HGY/2026/0872 Channing School, Highgate Hill, N6 5HF

G1: English Elm - Tree removal (see report)

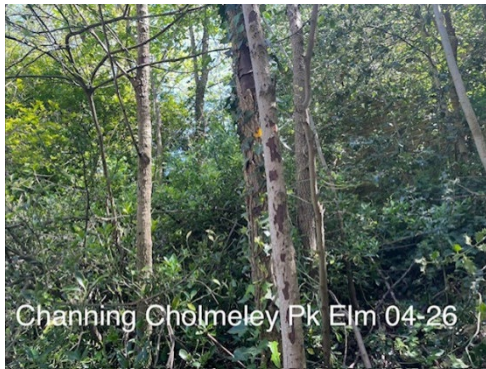
A look at the trees shows four young trees apparently suffering Dutch Elm Disease (not mentioned in the application)

It is unclear which trees along this section have a TPO but the 1869 25 inch Ordnance survey map clearly shows 8 regularly spaced trees along the boundary. Some of them are now missing. This would be a good opportunity to close the gap in the line of trees at this point, by planting a lime tree, consistent with the other trees in the group.
